REQUEST FOR CITY COUNCIL CONSIDERATION

Agenda Item: 6F	Prepared by: L. Suzanne Pritchard, PLA, AICP, CFM
Agenda Section: Unfinished Business: Ordinance. Second Reading	Date: November 27, 2024
Subject: Amendment to the Parkway Group Planned Development District (PDD) revising neighborhood three (Wax Myrtle) at Waterside [Z-24-30]	Division: Planning and Development
<u>History and Background:</u> City Council passed the amendment on first reading on September 16, 2024, with the understanding that the Developer would revise the plan to address concerns regarding density. During the October 7, 2024, meeting, the City Council postponed further consideration of the project to allow the Developer additional time to revise the plan. This revision was intended to not only address the original concerns regarding density but also reflect the Council's preference for the previously entitled plan, which oriented many of the interior residential lots toward ponds. <u>Proposed Changes:</u> The applicant, Robert "Shep" Guyton, acting as the Agent for the Developer, has requested an amendment to the Parkway Group PDD for the Wax Myrtle neighborhood. The amendment proposes a new layout for the Wax M

C1.01

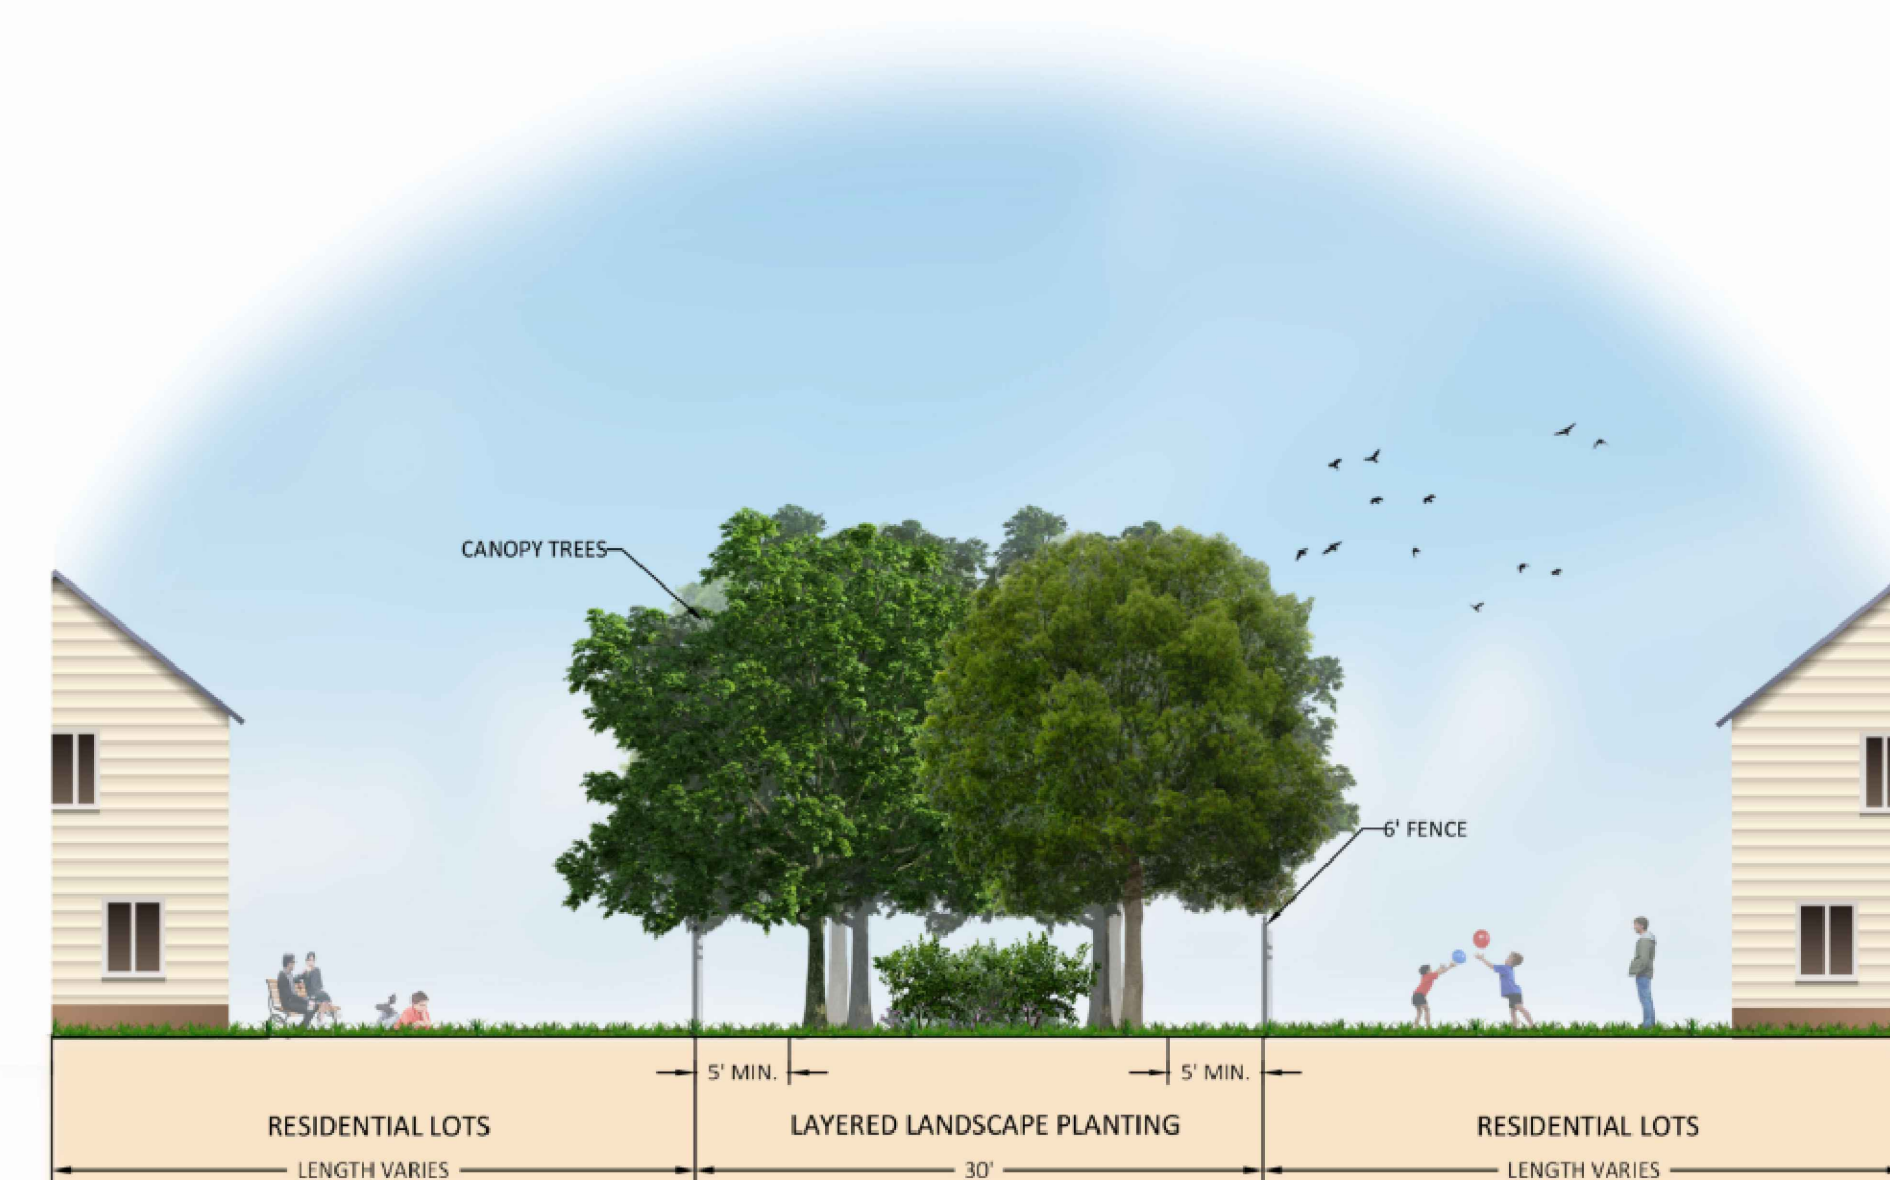
REVISIONS:		
1	11/11/24	REVISED PER CITY COUNCIL COMMENTS TO LAYOUT
2	11/26/24	REVISED PER ADD'L CITY PUBLIC WORKS COMMENTS

Exhibit A: Proposed Plan

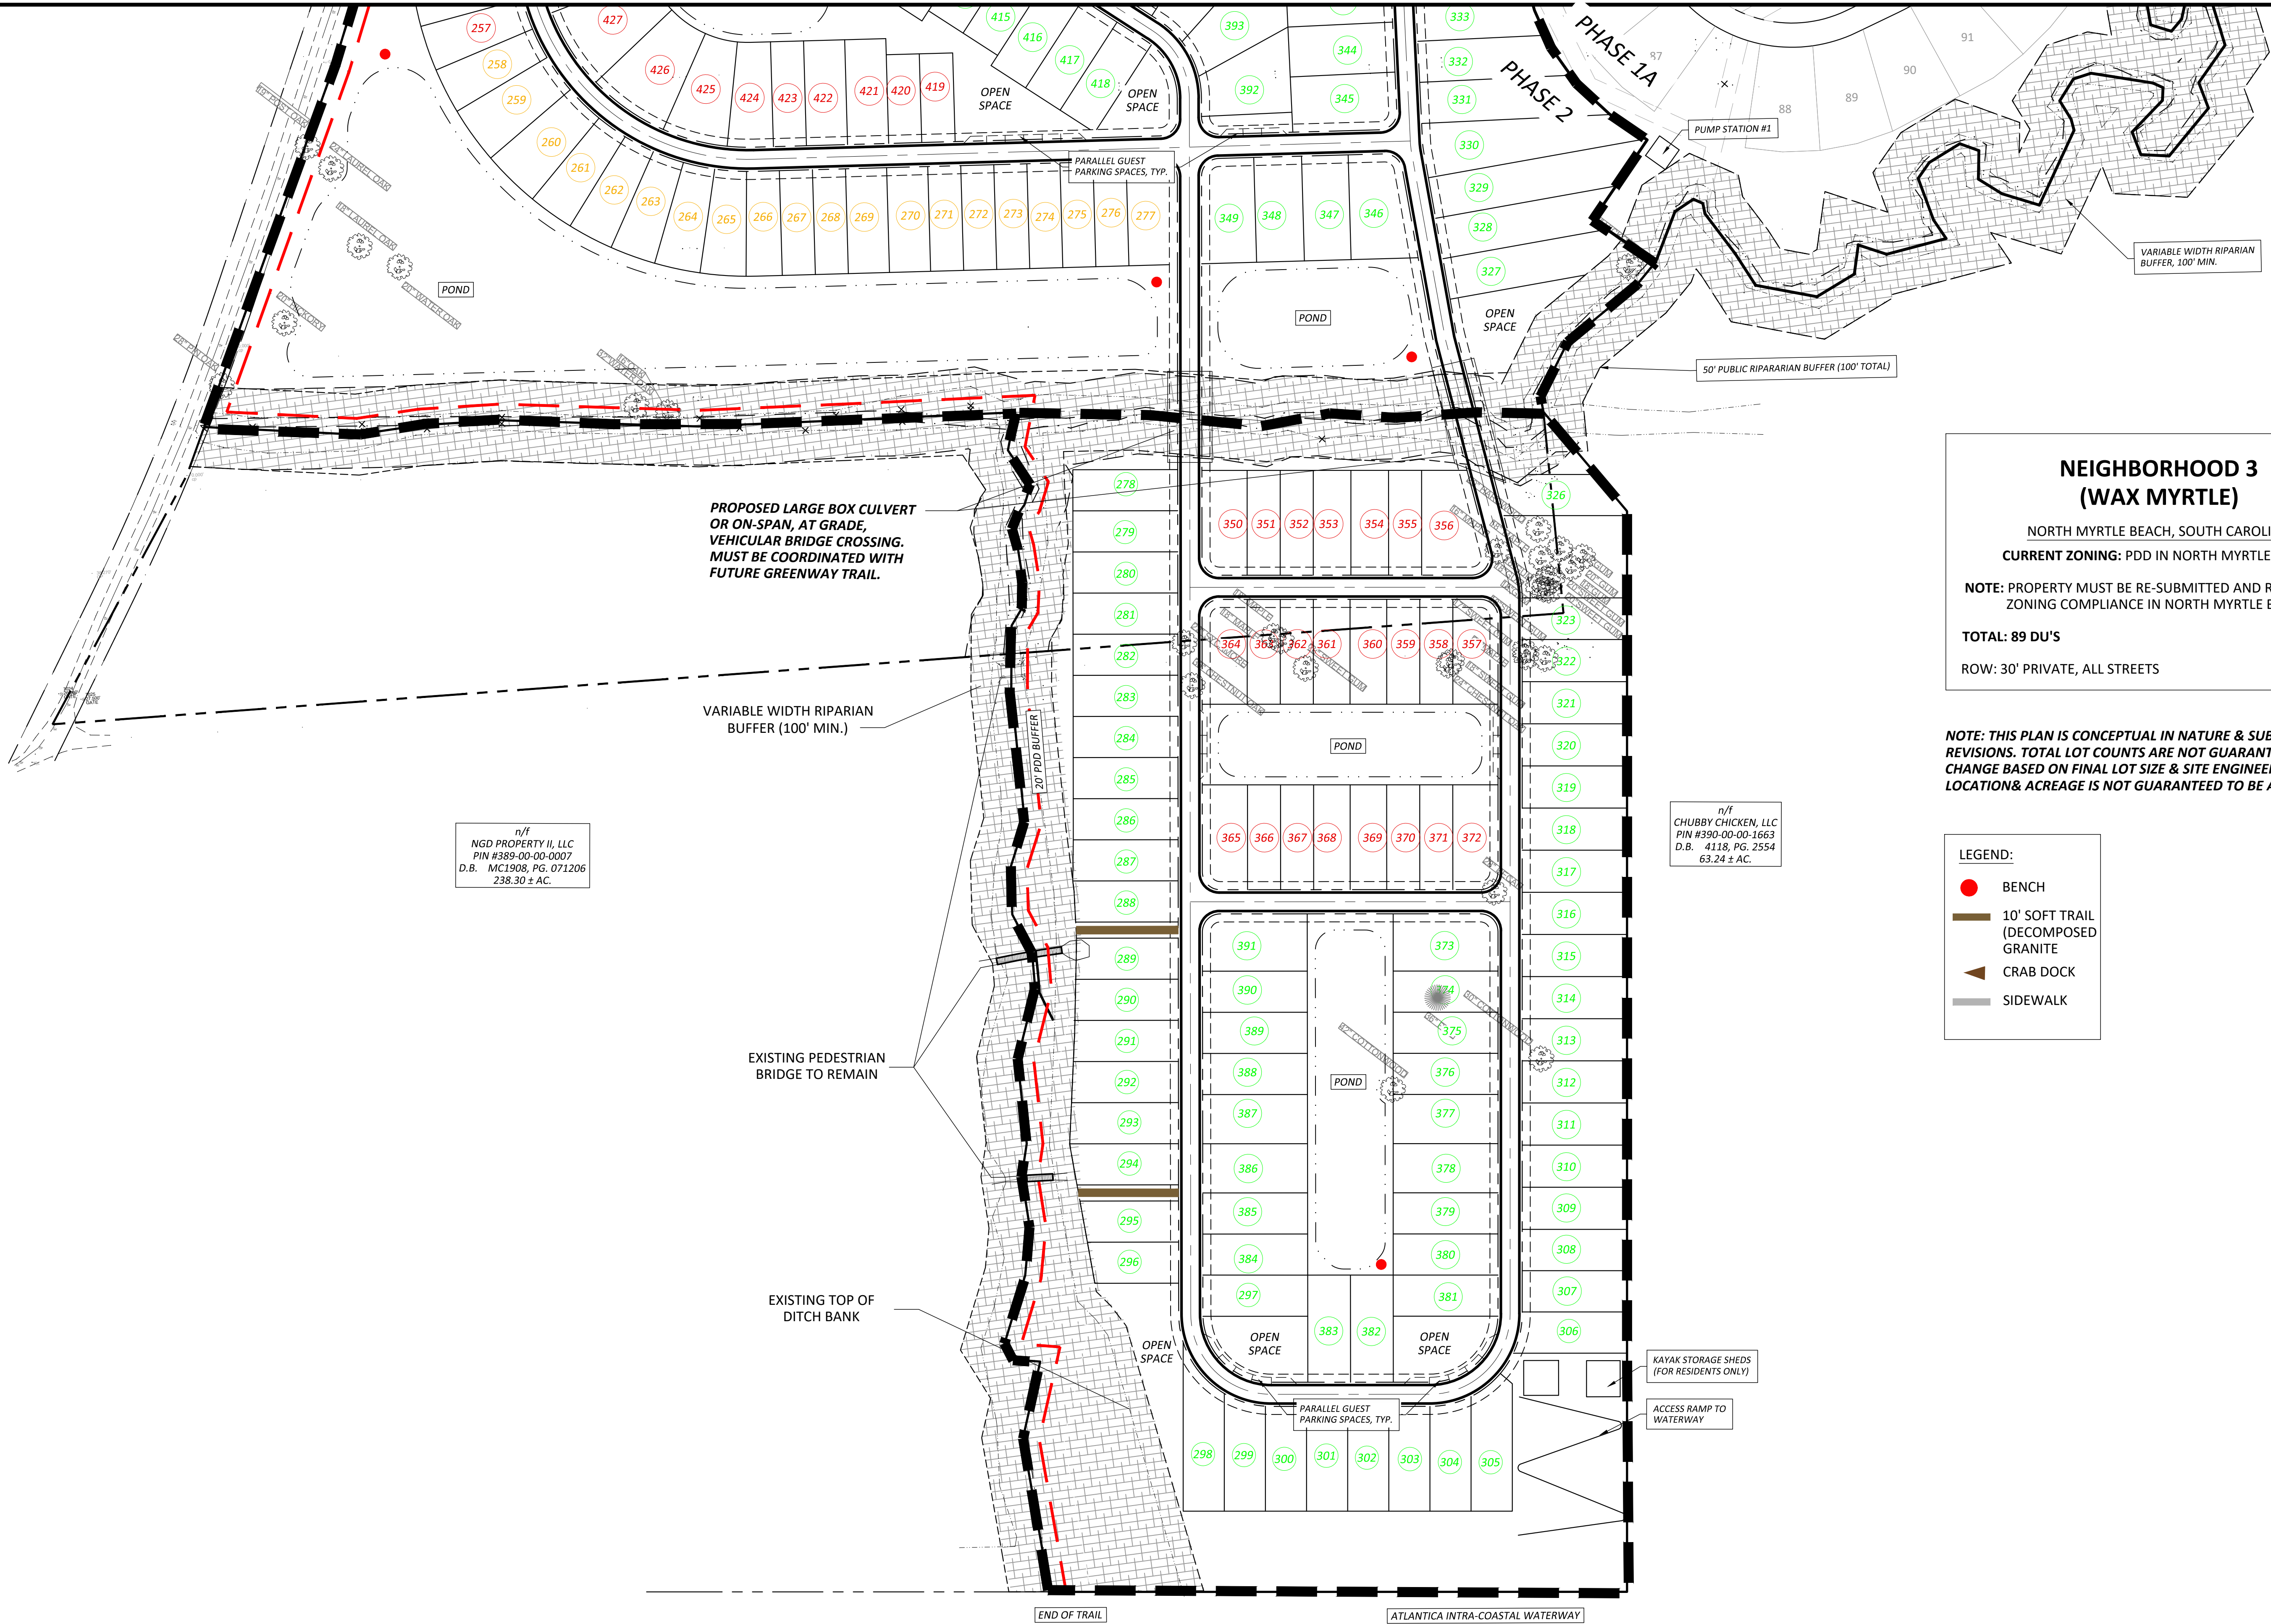
The Planning Department has no issue with the proposed amendment but notes a reconfiguration of the neighborhood could save the large stand of trees that the planning commission originally protected. By removing the short leg of road requiring a cul-de-sac for trash pick-up, the neighborhood would still have an increase in density of 10 units and the trees would be protected.
